REMEDIATION SYSTEM EVALUATION

BOG CREEK FARM SUPERFUND SITE
HOWELL TOWNSHIP, MONMOUTH COUNTY, NEW JERSEY

Report of the Remediation System Evaluation,
Site Visit Conducted at the Bog Creek Farm Superfund Site
April 16-17, 2002

EPA 542-R-02-015
September 2002
www.epa.gov/tio
clu-in.org/optimization

FIGURE 1-1. SITE FEATURES AND THE UPGRADIENT EXTENT OF BENZENE GROUND WATER IMPACTS AS DELINEATED BY PRELIMINARY DATA FROM THE SPRING 2002 SAMPLING EVENT.

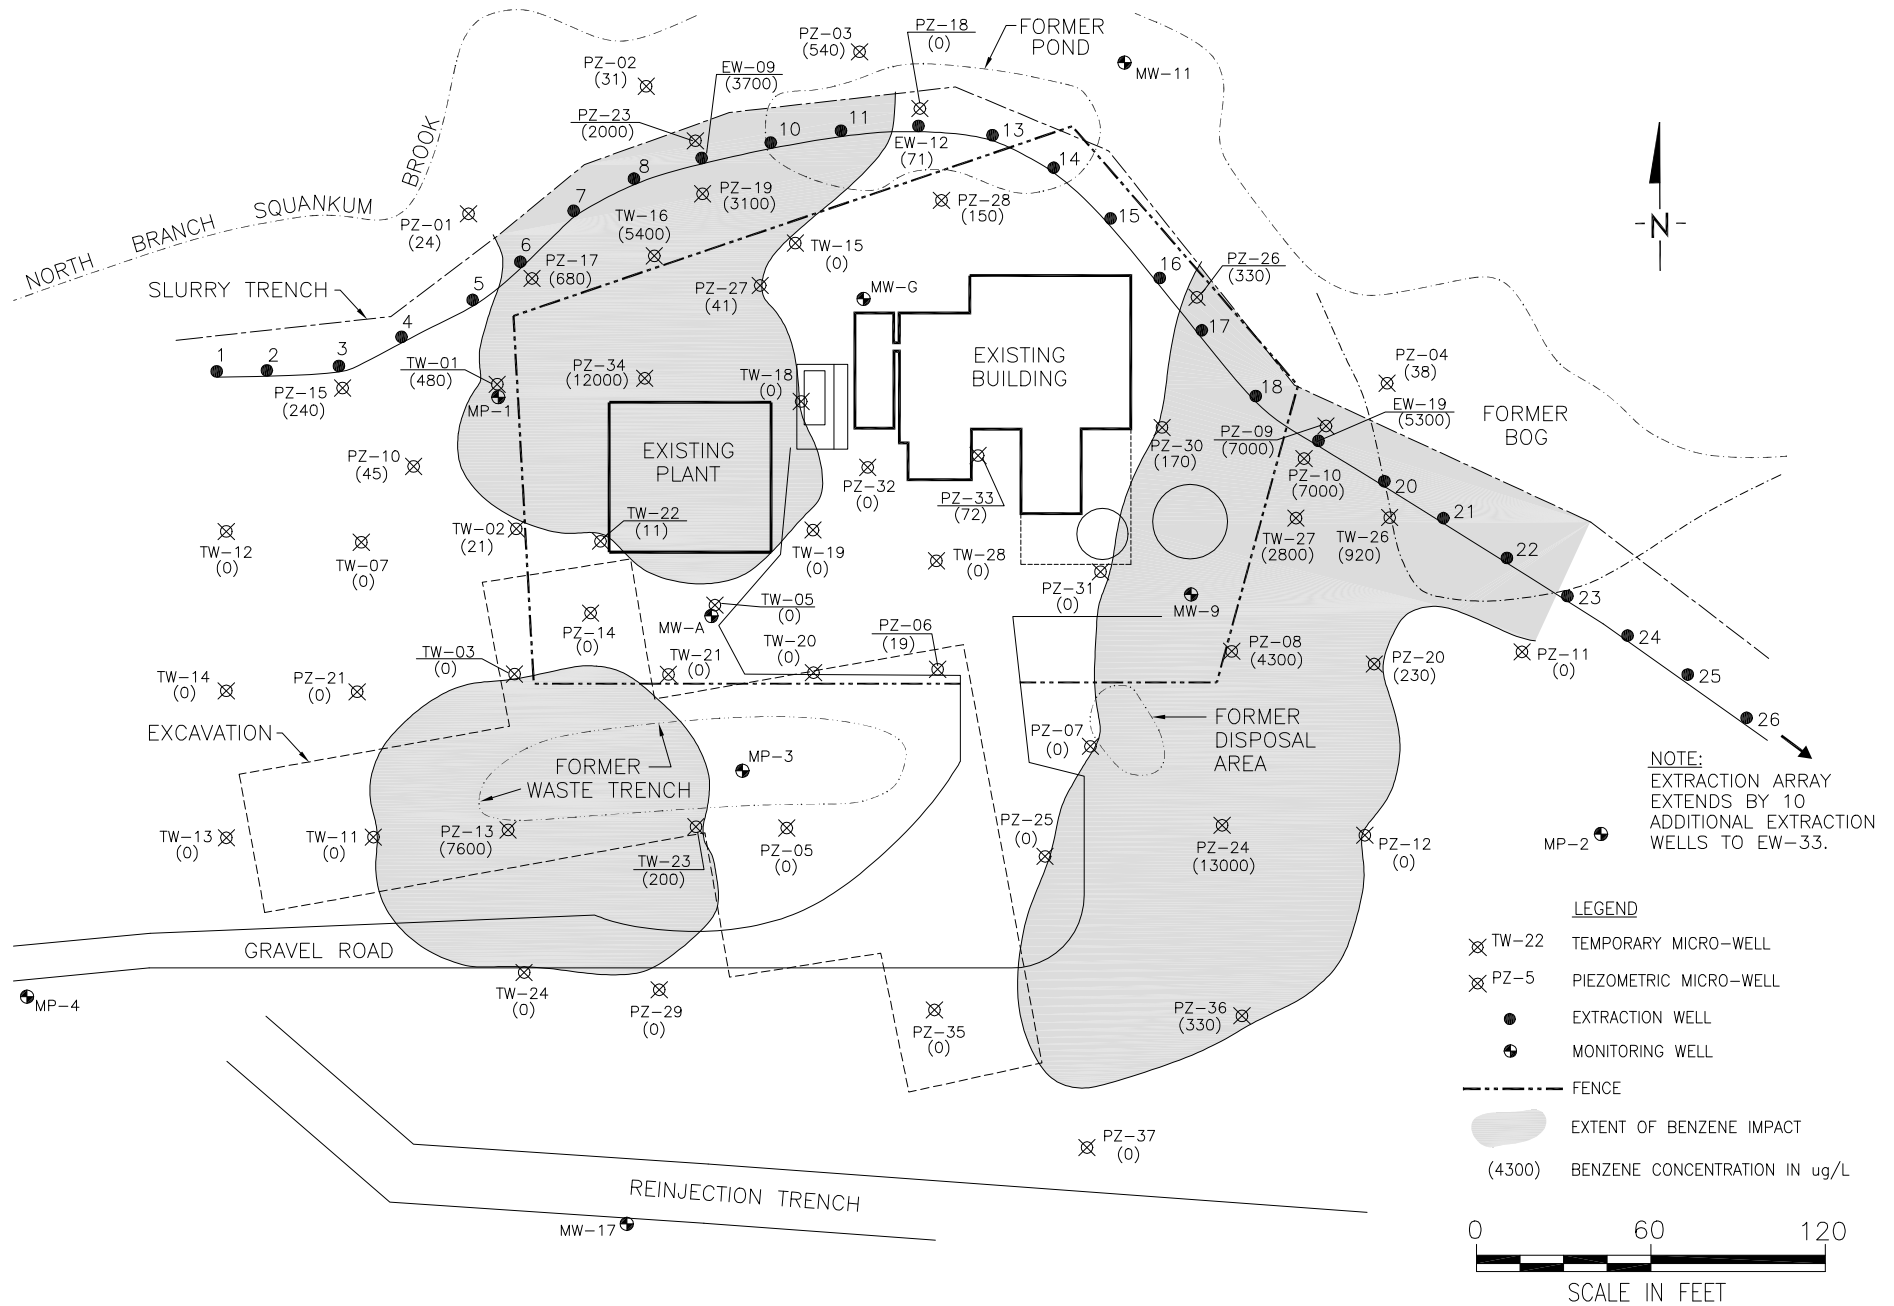
The capture zone at the site has not been analyzed; rather, it is assumed by the site managers that the slurry wall and extraction network provide capture. Sampling from the December 2001 GeoProbe event indicates benzene impacts beyond the slurry wall and extraction network at all four locations evaluated. The highest benzene concentration in the four locations was 540 ug/L at PZ-3. The site managers assume that these impacts were present before the installation of these remedy components, and they plan to continue monitor concentrations in the piezometers beyond the slurry wall. An increasing trend in concentration will indicate a lack of capture and decreasing concentrations will indicate sufficient capture.

Further exploratory sampling conducted through the REACs contractor in December 2001 and Spring 2002 yielded further delineation of the benzene and toluene impacts. The December 2001 event consisted of GeoProbe sampling of ground water with temporary wells. The results show areas of benzene concentrations exceeding 10,000 ppb and toluene concentrations of up to 100,000 ppb further upgradient (more than 50 feet) of the extraction network. These elevated concentrations mark a significant departure from the understanding of ground water impacts throughout the site because previous sampling was limited to monitoring wells that had comparatively low impacts. Moreover, all four piezometers located downgradient of the extraction network and slurry wall reveal impacts of benzene. At PZ-3, these impacts exceed 500 ppb.

FIGURE 6-1. THE ESTIMATED EXTENT OF SIGNIFICANT VOC CONTAMINATION AS INDICATED BY DATA FROM THE DECEMBER 2001 SAMPLING EVENT AND PRELIMINARY DATA FROM THE SPRING 2002 SAMPLING EVENT.

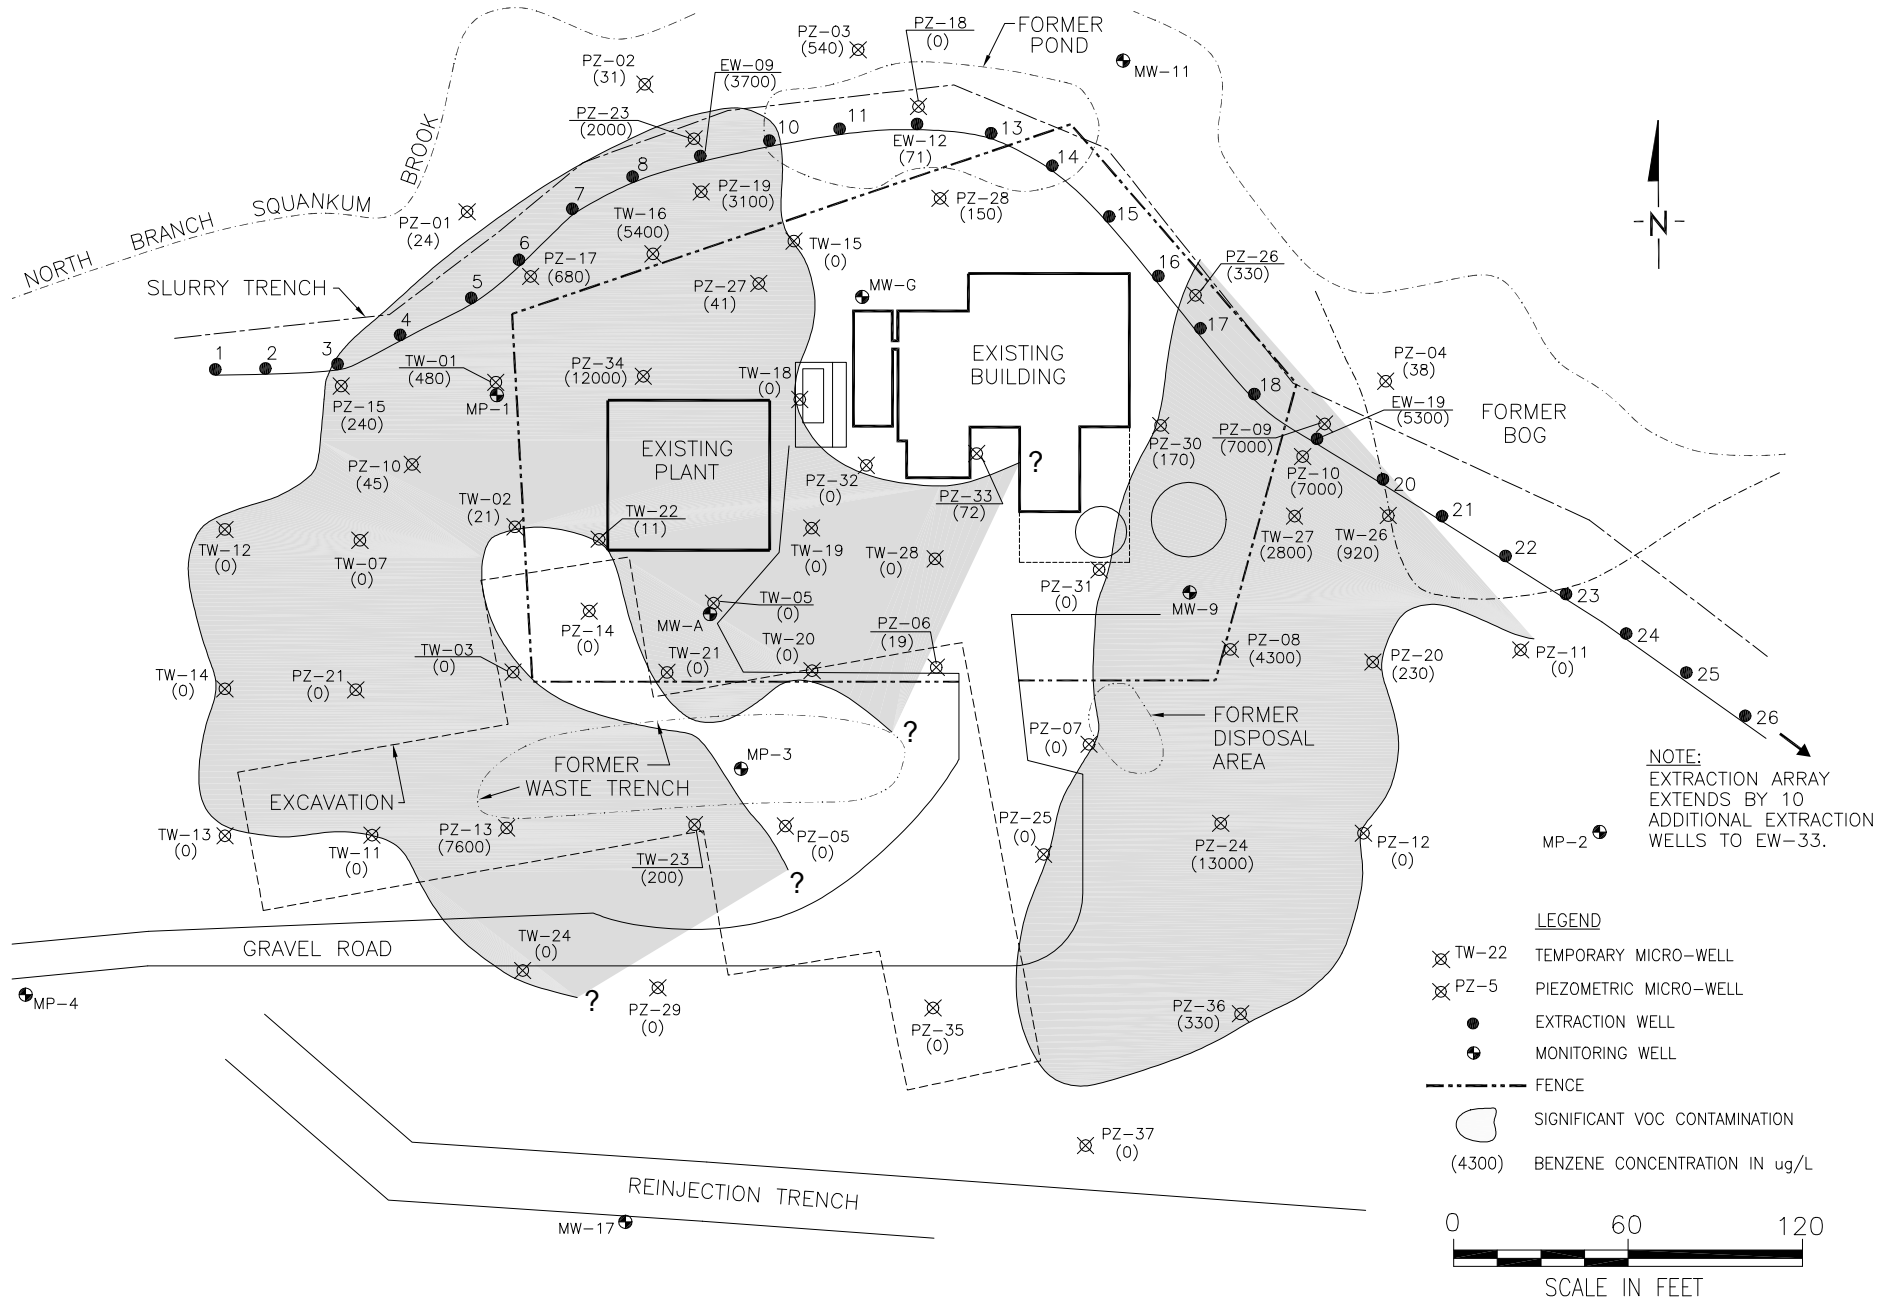
Figure 6-5 illustrates the areas of significant VOC contamination (based on preliminary data) where treatment of this technology should be considered. To proceed with this approach, the site managers will either need to make assumptions about the extent of the contamination or will need to conduct additional direct-push sampling to help further delineate the exact areas for treatment. Considering the constituents of concern, the observed concentrations, the volume to be treated, and the depth to ground water, approximately 60 injection wells might be required. The cost of each well—including installation, injection, and monitoring of the injection— would range from \$5,000 to \$10,000. Therefore, the cost of implementation would likely range from approximately \$300,000 to \$600,000. Because contamination is limited to shallow portions of the aquifer, delivery could be accomplished through trenches or infiltration galleries, which might reduce the cost. As a contingency, the RSE team will assume that the cost of such a remedy will be up to \$1 million.

Excavation could be extensive and comparable in size to the area of significant VOC impacts depicted on Figure 6-5 or it could be limited to specifically defined areas with residual NAPL or source material. The area of significant contamination is approximately 60,000 square feet. Assuming an excavation depth of 15 feet, extensive excavation would involve removal of approximately 900,000 cubic feet (approximately 30,000 cubic yards). Perhaps 75% of this material (or over 20,000 cubic yards) would require treatment. Assuming
